September 13, 2016  
PERMIT MODIFICATION APPROVAL  
Horizontal 6A / Horizontal 6A Well - 1

Re: Permit Modification Approval for RPT8-4U  
47-095-02330-00-00

Extend Lateral and Modify Casing

RE: RPT8-4U Wellbore Location Extension Exception Letter

FILE NO. \_\_\_\_\_  
DRAWING NO. 1  
SCALE 1" = 2000'  
MINIMUM DEGREE OF ACCURACY 1 in 200  
PROVEN SOURCE OF ELEVATION GPS  
submeter unit

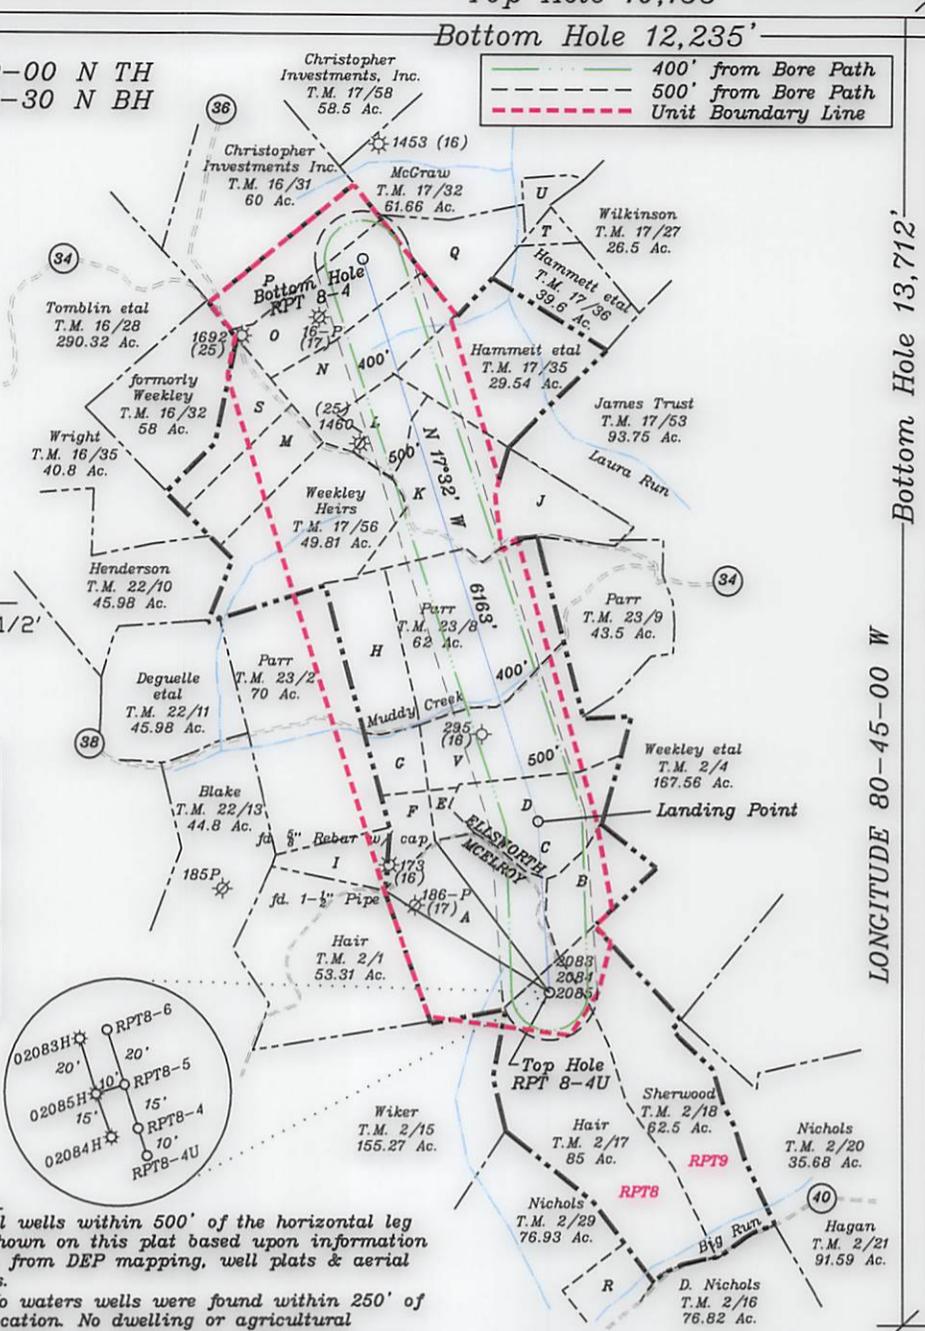
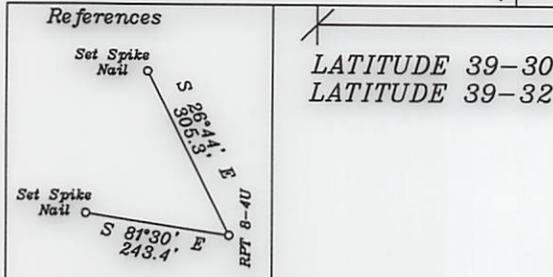
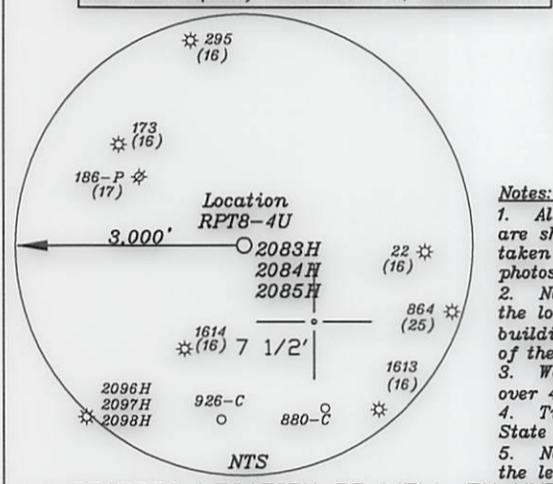
The deep well review of the application for the above company is **APPROVED TO UTICA.**  
Modification: extended lateral and adjusted direction slightly

Jay-Bee Oil & Gas, Inc. is seeking authorization to extend drilling of the RPT8-4U (API 47-095-02330) deep well lateral, also slightly adjusting direction.

We would like to extend drilling our lateral to 410' off of our unit boundary. Extending the lateral would allow us to capture additional potential natural gas production from our unit. Due to time constraints and contractual commitments with a horizontal rig, we would like to request a speedy review and approval of this modification.
